Woburn Safe Routes to School

Walkability Assessments

Introduction

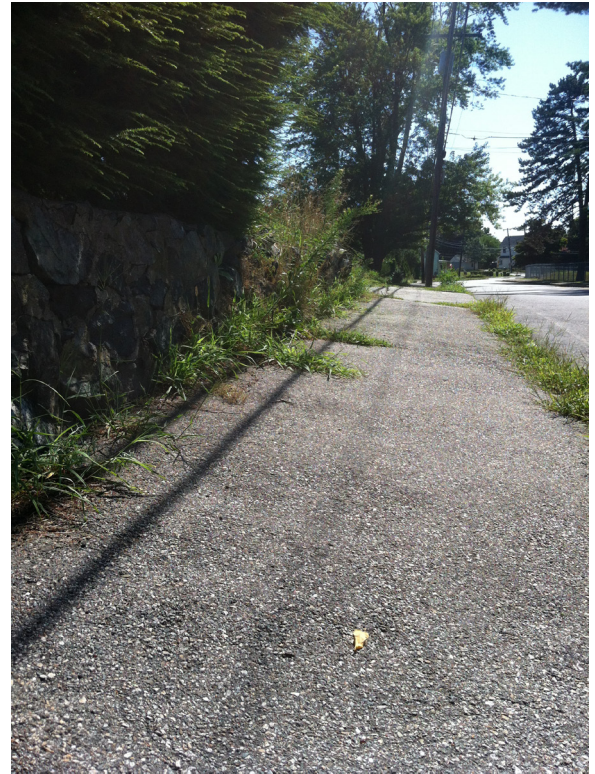
The neighborhood east of Kennedy Middle School, which is connected to Beach Street by Maple Street, is close to the rear of school “as the crow flies,” but it is a long walk because of the lack of street connectivity. (See Figure 16)

Recommendations: An informal path through the wooded area between Overlook Terrace at the western edge of the aforementioned neighborhood should be cleared, improved, and perhaps lighted. This would provide a safe connection to the school grounds that would be much shorter for people trying to walk or bike to Kennedy Middle School, and increases the likelihood that children from this neighborhood would choose to walk or bike to school.

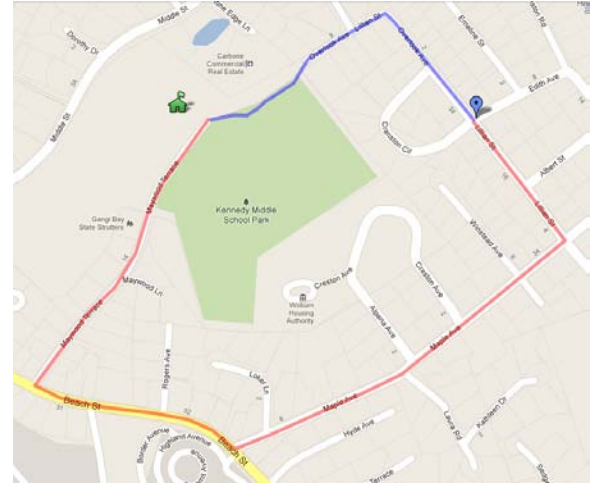
The crosswalk at Houghton Street and Bedford Road provides less than optimal visibility for pedestrians crossing Bedford Road, especially those crossing toward the Hurld School. Bedford Road bends slightly, to the west of the crosswalk, so pedestrians would be unable to predict if a vehicle were approaching from their left. The problem is made worse by tall hedges at the edge of one of the properties on the south side of Bedford Road. This crosswalk is also missing a curb ramp on the north side of Bedford Road. (See Figure 17)

Recommendations: Remove this crosswalk and place a new crosswalk to the east where pedestrians would have better visibility and a more direct connection to the school grounds. This new crosswalk should be a highly visible ladder style, not simply a pair of parallel white lines. Accessible ramps should also be installed, as well as brightly-colored pedestrian crossing signage. This would be the only crosswalk in the school zone, so it should be made as visible as possible.

Figure 19

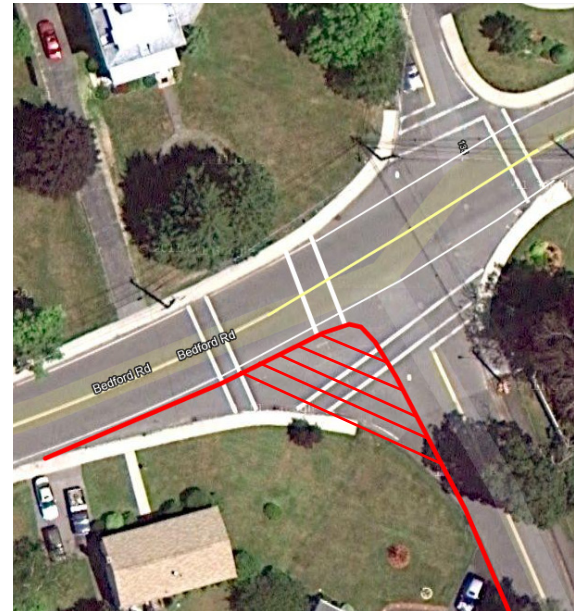
across Bedford Road west of Burlington Street, as well as Burlington Street south of Bedford Road, are longer than they need to be. As a result, pedestrians are “exposed” to traffic for more time than necessary. Furthermore, the large turning radius allows drivers turning right onto Burlington (south of Bedford Road) to do so at a faster speed than they would if the corner were sharper. (See Figure 19)

Recommendations: Painting curb extensions and installing flexible delineators would effectively narrow traffic lanes and shorten crossing distances. This would also slow vehicle speeds around corners.
